Staff Report

To: Historic Landmark Commission

Re: Petition PLNHLC2017-00560 for New Construction at 1117 E South Temple Street
Petition PLNHLC2017-00763 for Special Exceptions at 1117 E South Temple Street

NEW CONSTRUCTION & SPECIAL EXCEPTION IN HISTORIC DISTRICT

SHEET TITLE
SITE PLAN - GRADING

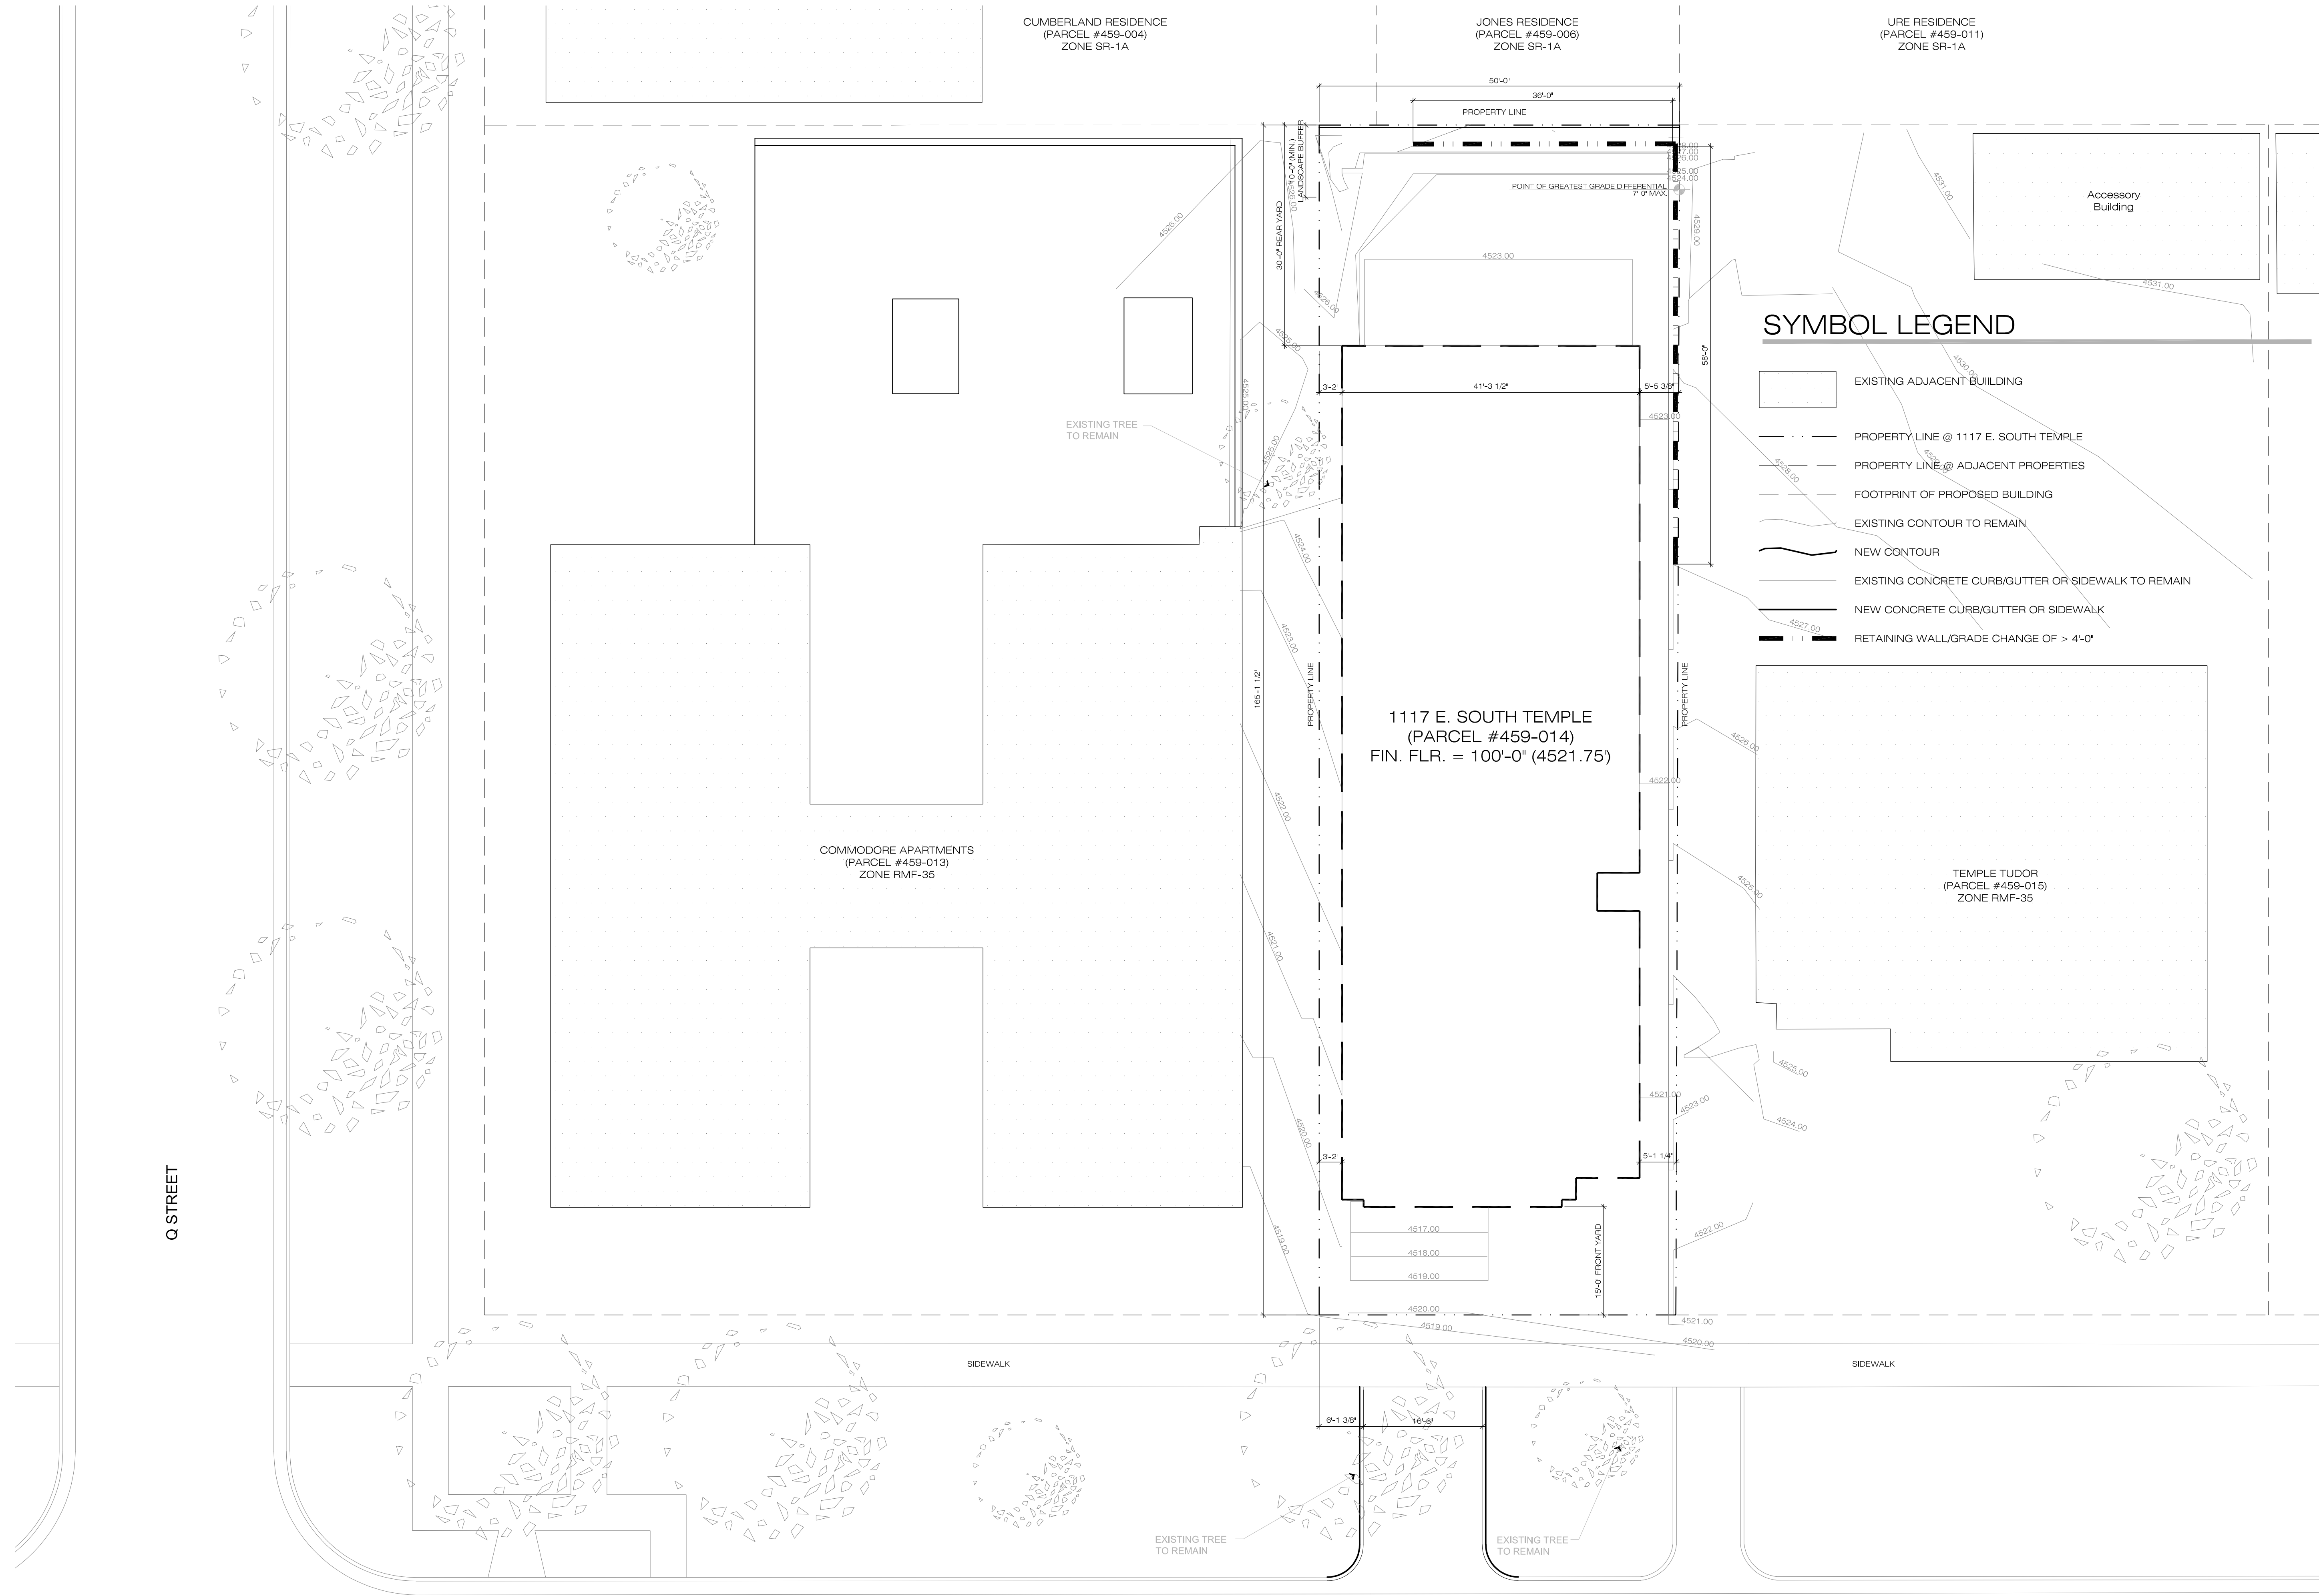
Furthermore, any grade changes in excess of 4'-0" **also require ‘special exception’ approval**, which may or may not be required, depending on the proposed grading plan, which again has not been submitted to the City for review yet.” (September 7, 2017 Historic Landmark Commission Memorandum)

Response. As stated previously, the applicant submitted a special exception petition on September 13, 2017. However, the application failed to include the existing and proposed grading plan. The applicant corrected this oversight and submitted the attached grading plan on November 16, 2017 (see Attachment F – Grading Plan).

ATTACHMENT G: LANDSCAPE PLAN

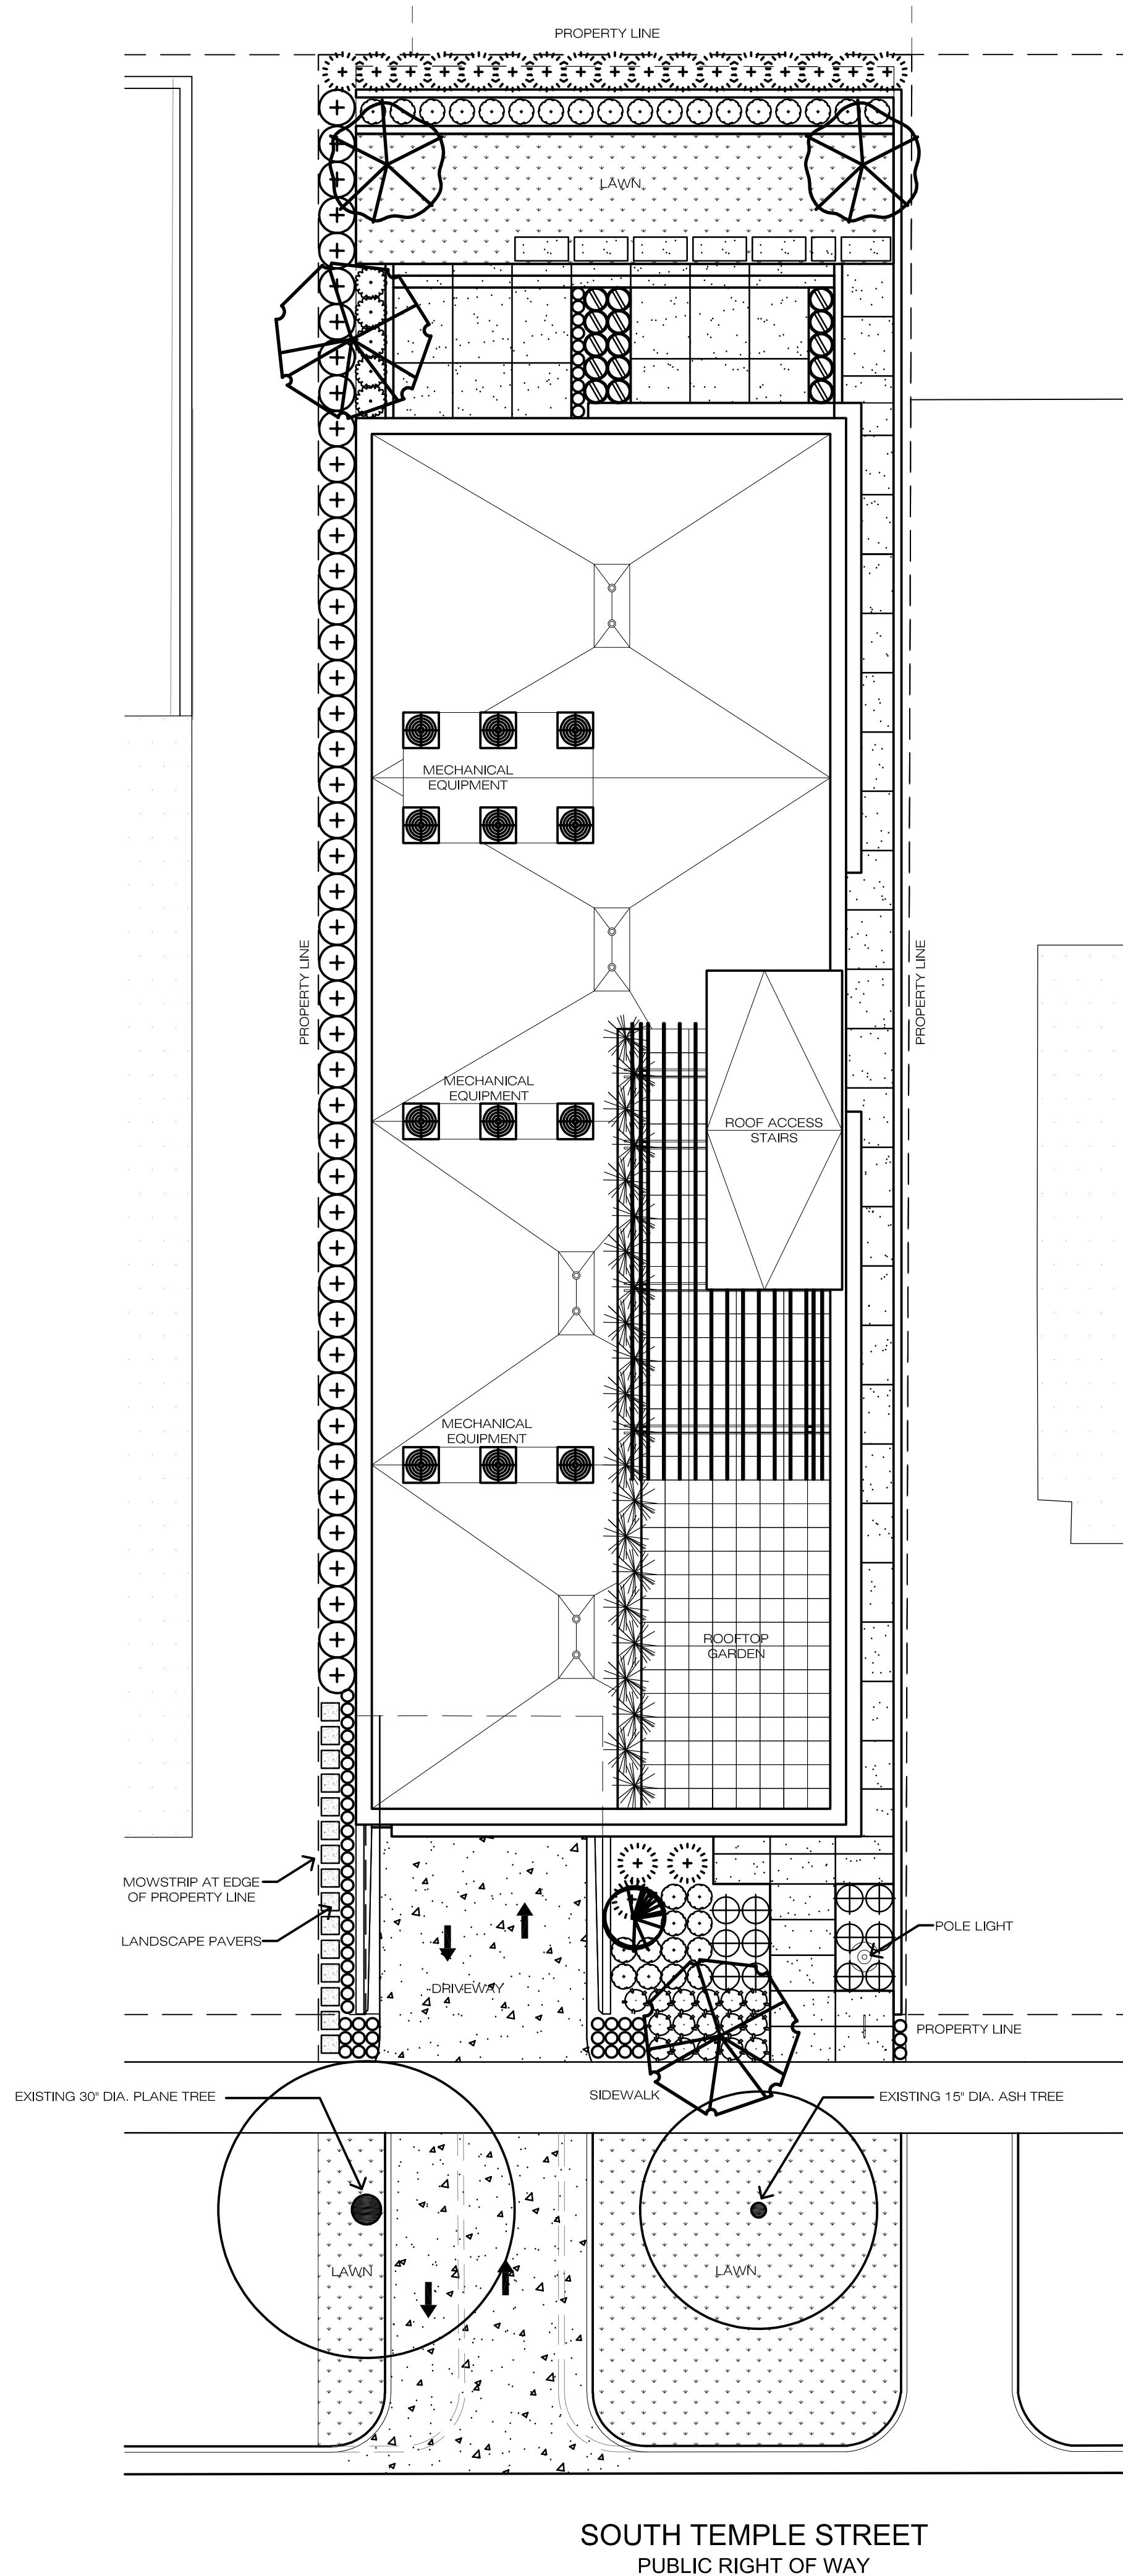
Issue 7 – Landscape Plan. “Although the amount of planned open space exceeds the minimum requirement, accessible landscaping will be relatively minimal. As such, staff recommends the project architect work to ensure that landscaping compliments the building

and site rather than becoming an afterthought. The applicant has also expressed strong interest **in creating a ‘green roof’**—which would be a welcomed feature—but it is not clear if the rooftop garden would be accessible to all residents or restricted to a single unit. Again, a detailed landscaping and grading plan has not been submitted to the City for review yet.” (September 7, 2017 Historic Landmark Commission Memorandum)

Response. Within the revised plans attached to this staff report, the applicant submitted a **landscape plan for the Commission’s review (see Attachment G – Landscape Plan)**. The landscape plan includes the roof terrace, which will be fully accessible to all residents of the development. The final landscape plan will be reviewed for zoning compliance during building permit review, however staff finds the preliminary landscape plan is appropriate for the historic district given the limitations of the narrow site.
